RE: Planning application: 137226/FO/2023 and 137227/FO/2023

Crown Street – 137226

Plot D – 137227

Reference to Figure 4 - as of August 2025

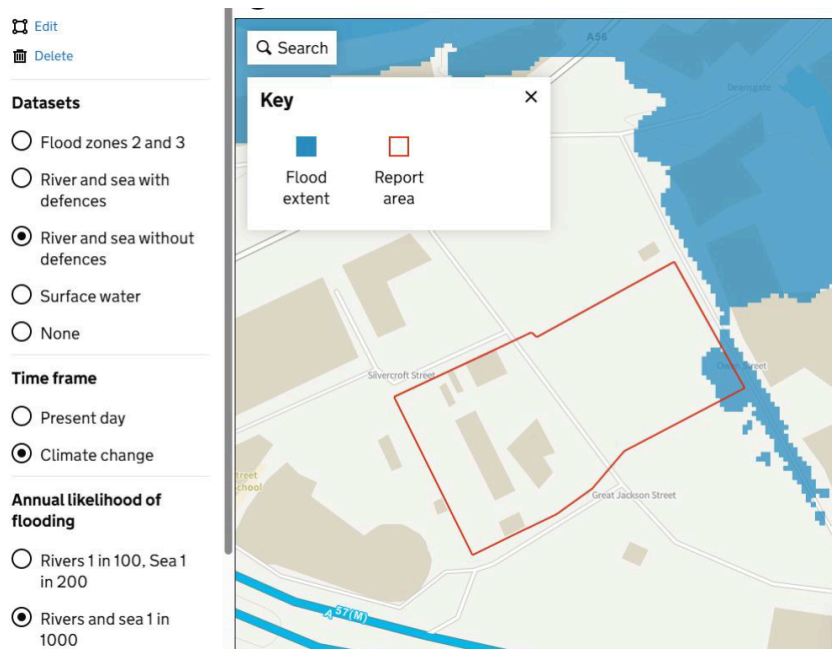
There is a small area of land to Owen Street / Melbourne Street corner of Plot E2 that has a chance of 1% AEP + CC.

At the time of writing the addendum report (August 2025), it was noted on the EA mapping that there could be a 1 in 1000-year (0.1%) chance that a small portion of the site (namely the corner of Plot E2) could be impacted by fluvial flooding during defended and undefended scenarios for the period between 2070 and 2125. (As demonstrated in Figure 4 of the report – and extracted below).

The applicant could update the FRA with the FFL details and details of property flood resilience measures. We could then mark the FRA as an approved document and that the proposal should be constructed in accordance with the FFL recommendations in the Flood Risk Assessment. Otherwise we can amend the wording to:

b) "Details of Finished Floor Levels set in accordance with Standing Advice, a minimum of 300mm above the estimated flood level for the 1% AEP + Climate Change allowance event. Where FFLs cannot be raised, PFR can be proposed. PFR measures must protect to a minimum of 600mm above the estimated flood level."

Updated Mapping as of September 2025

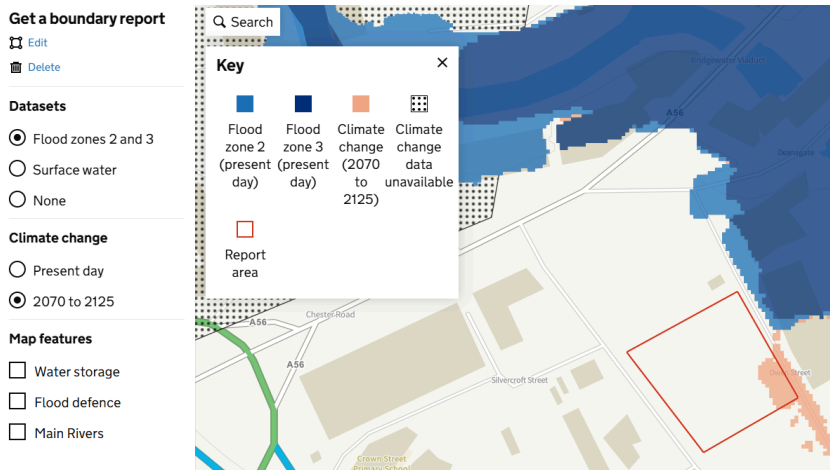
The latest mapping (update in September 2025) with climate change extents shown in orange (as shown in the mapping below) now only confirms how the combined extent of flood zones 2 and 3 could increase with climate change over the next century, which means only the full extent of the 1 in 100 and 1 in 1000 year risk plus climate change risks can be seen, which doesn't provide the 1 in 100 year plus climate change risk alone.

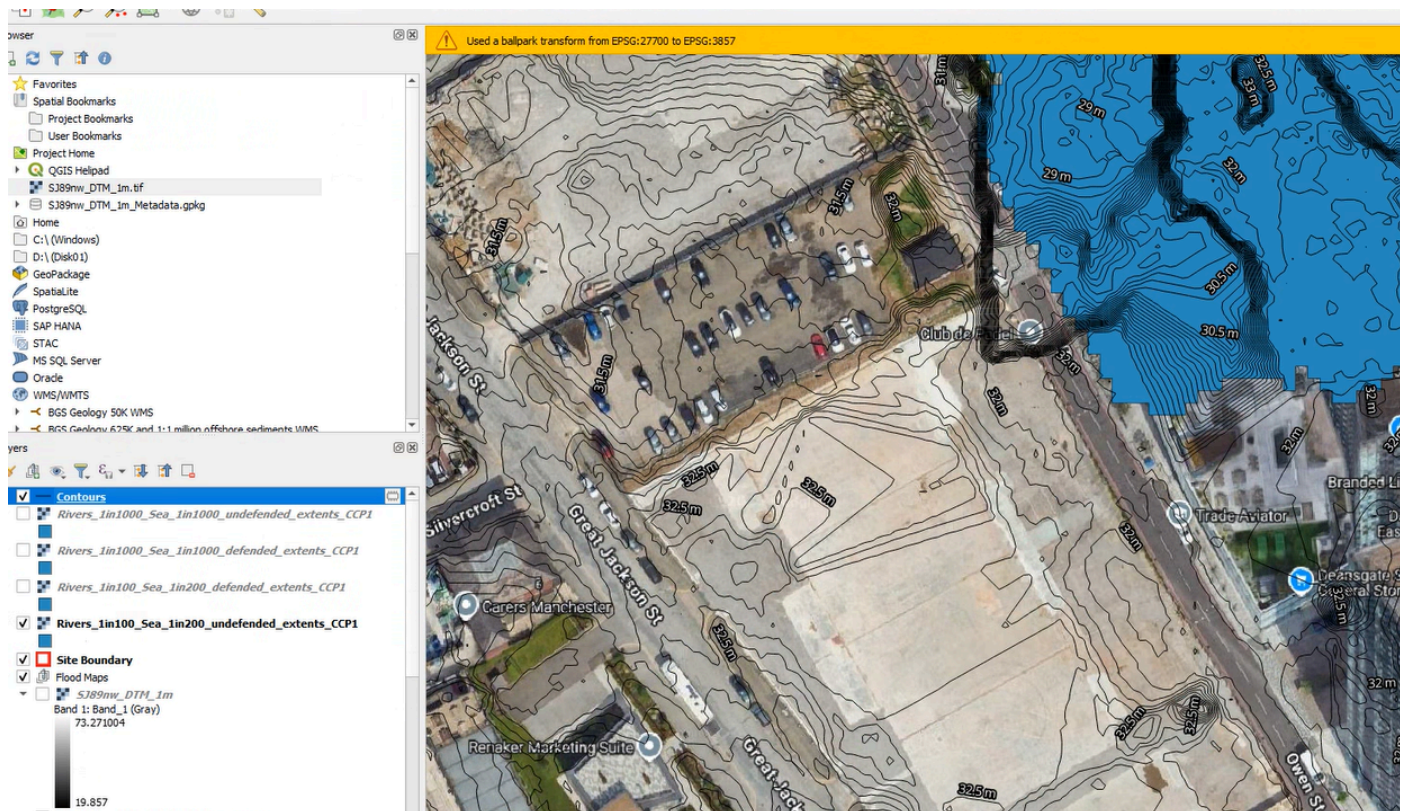
To ascertain the predicted flood level at the **1in 100 year +cc** projected extents Curtin's has downloaded the available LiDAR data and flood extents data from the government website, which is dated 27/08/2025 (overlay extract below). This indicates that the expected flood water extends to a level between **31.5-31.9m**. However, the Lidar data doesn't appear to be completely up to date around Deansgate Square and the flood extents don't align with a consistent contour line.

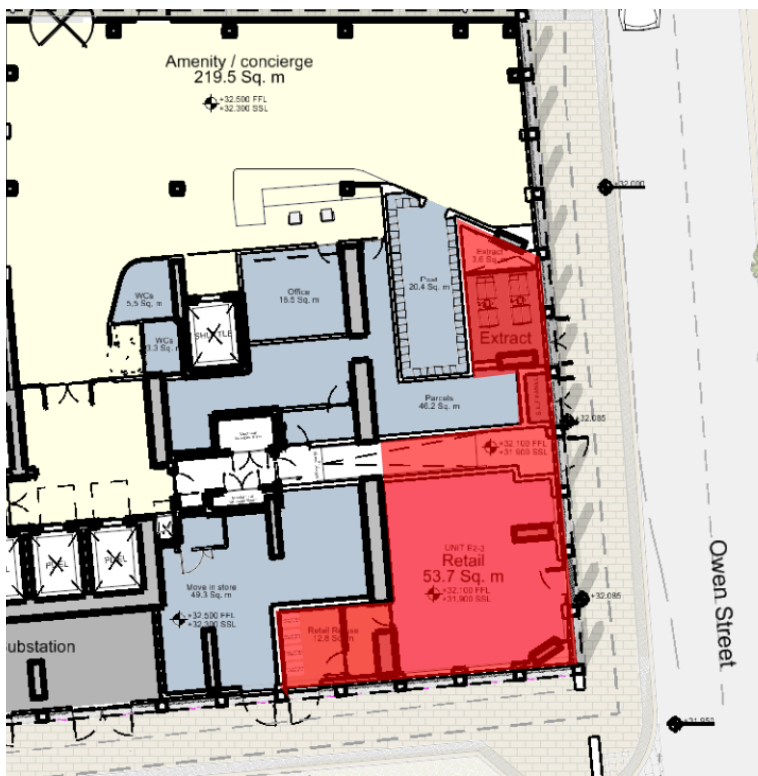
The area highlighted in red on the proposed floor plan below has a FFL of 32.100m, all other areas are at a FFL of 32.500m. Taking the worst-case position, the FFL at 32.1mm would be 200mm above the highest flood level of 31.9m.

The FFL cannot be amended as it needs to tie into the existing levels at Owen Street.

The area in question represents a small part of the site and is proposed for a less vulnerable use (Retail) and plant that can be accommodated above the 300mm flood level. It is therefore proposed that the wording of the condition is amended to provide sufficient flexibility to allow for resilient construction practices to be included (such as ensuring all electricals / plant etc are at least 300mm above the flood level) and for an emergency plan to be in place in the event of any flooding.

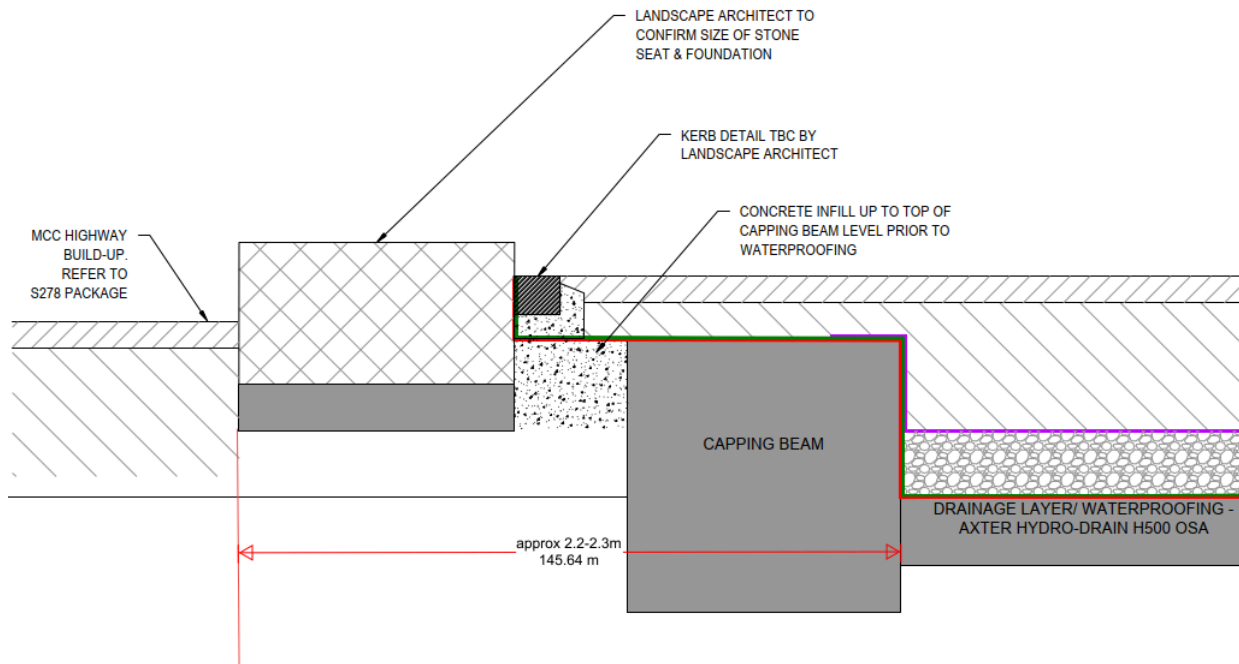
e) Where a public sewer diversion or abandonment is required, an agreement in principle from United Utilities is required. An email of acceptance will suffice.

f) Where a public sewer diversion, abandonment or build-over is proposed, agreement in principle from United Utilities is required. An email of acceptance will suffice.

E and f to be removed – there are no public sewers, therefore not applicable.

e) & f) – On further review, the mapped sewer on site is shown as privately owned rather than public sewer. Happy for these two clauses to therefore be removed.
